Subject: Docket No. 71-9270 (TAC No. L22452)

Submittal of the NAC Responses to the NRC Request for Additional Information (RAI) on the UMS<sup>®</sup> Universal Transport Cask Application, Chapter 2 Structural Evaluation

**NAC INTERNATIONAL RESPONSE  
TO  
REQUEST FOR ADDITIONAL INFORMATION**

Figure 2.50-1 Typical Filtered Acceleration (Top Accelerometer) Time History for the Quarter-Scale Model Side Drop, Overlayed with the Unfiltered Data

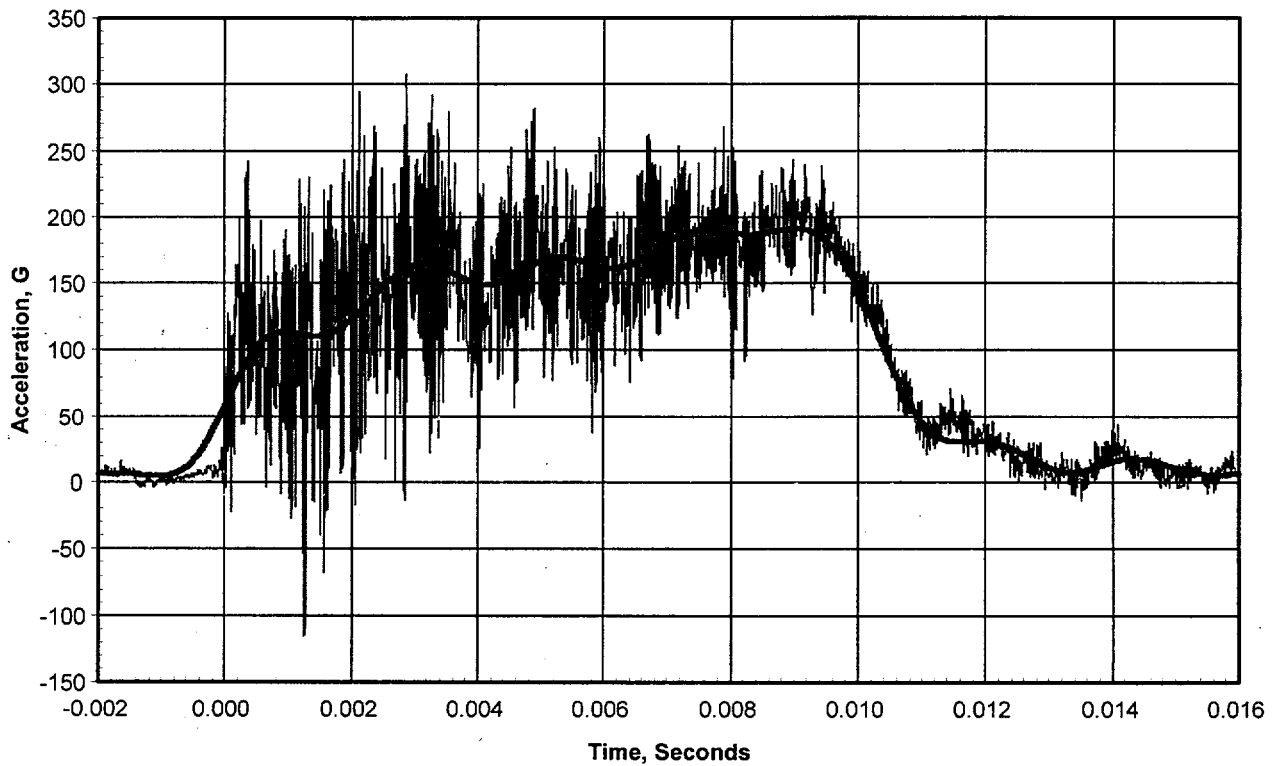
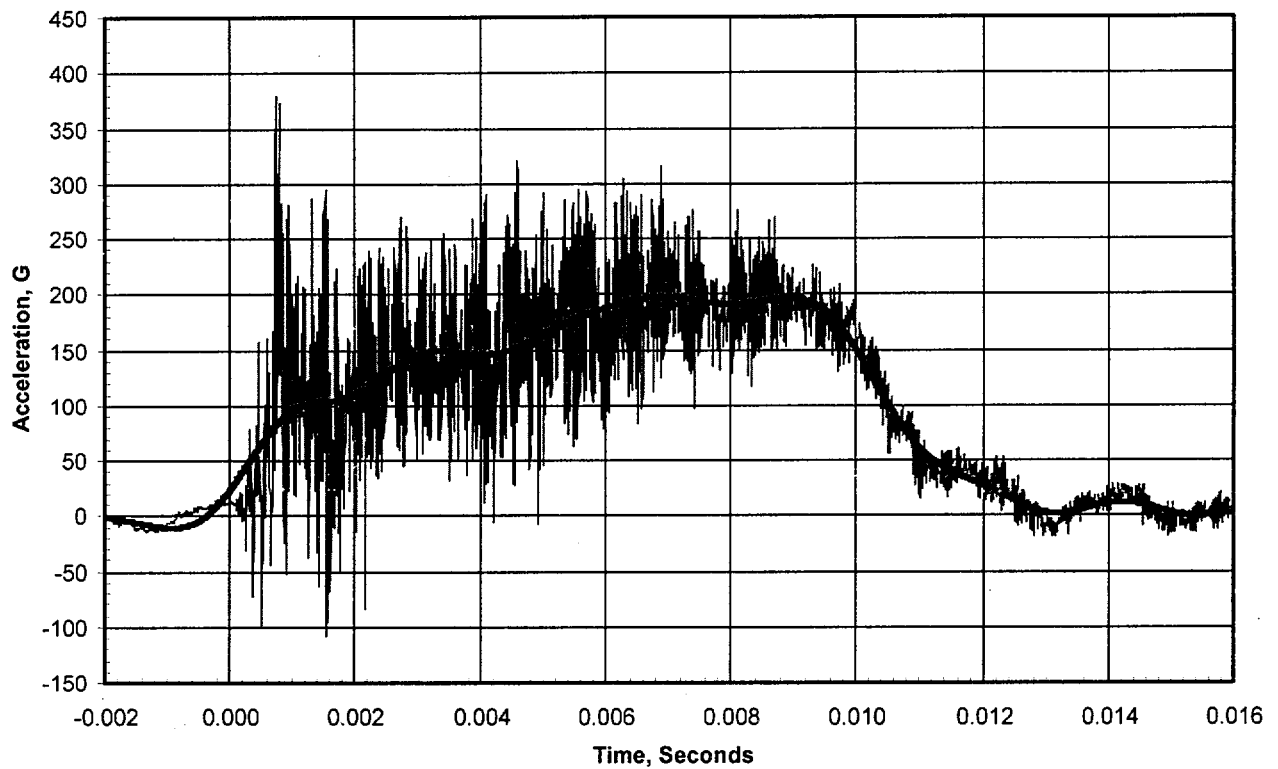
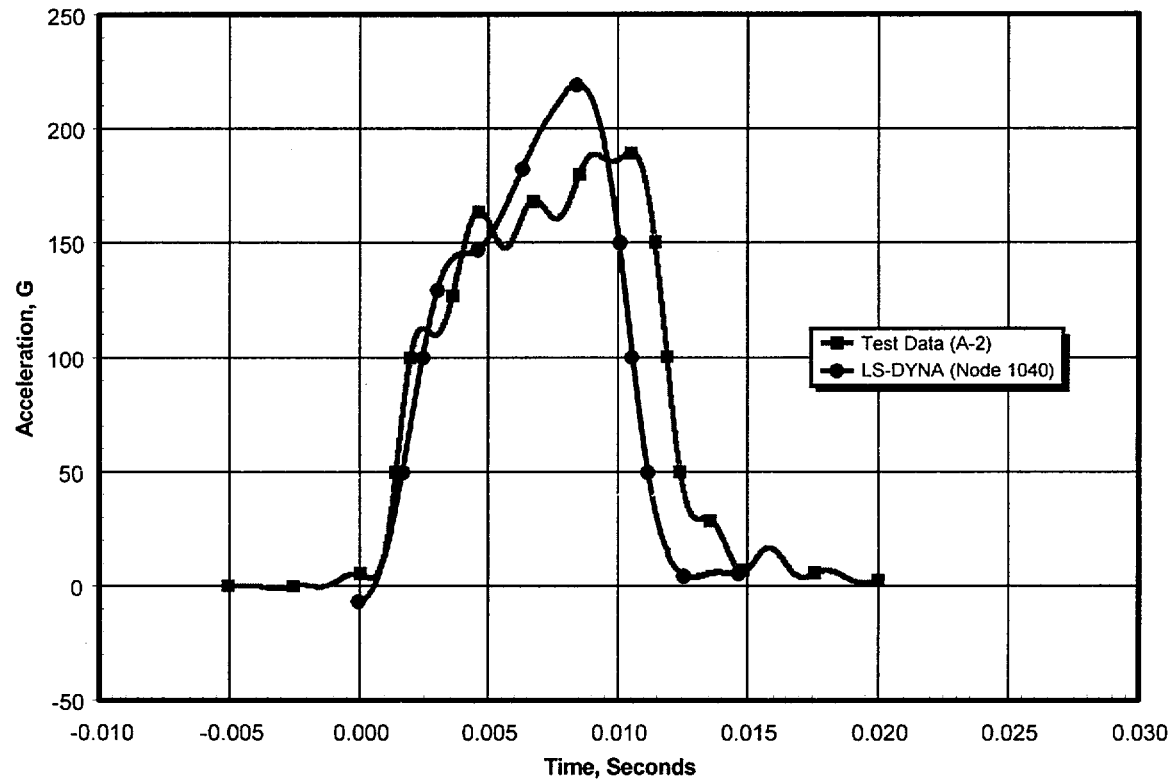
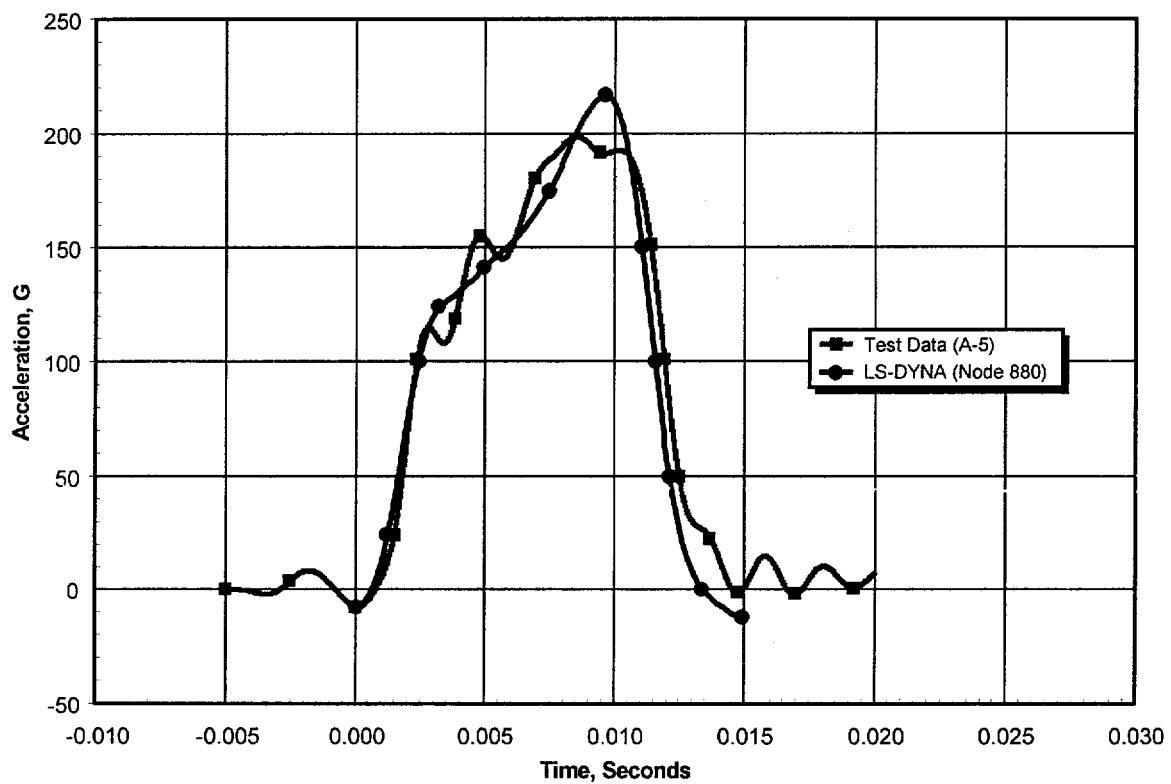
1.      The 1/4-scale cask model should also provide proper simulation of the cask mass moment inertia, in addition to the mass and its center of gravity. The use of weight disks at only the cask top end may not be representative.
2.      The measured acceleration time history in Figure 2.10.3-6 suggests significant cask rocking, which is uncharacteristic of a Universal Transport Cask undergoing side-drop response.
3.      The end-drop acceleration time history in Figure 2.10.3-1 appears to contain much more spurious components than the similar time history for the 1/4-scale drop test conducted for the NAC-STC.

2. A side drop test performed at Sandia National Laboratory on March 13, 2001, showed none of the uncharacteristic rocking response noted during the Oak Ridge side drop test. Figures 2.50-1 through 2.50-4 of this response show the filtered and unfiltered test results and compare the LS-DYNA analysis prediction to side drop test data. These results and details of the Sandia test have been added to Section 2.10.3.7.
3. The method of filtering the acceleration for the end drop was reviewed and was correlated with the balance of energy. This is reflected in the energy absorption traces for all three accelerometers used in the end drop. These figures are presented in the response to RAI 2-51.
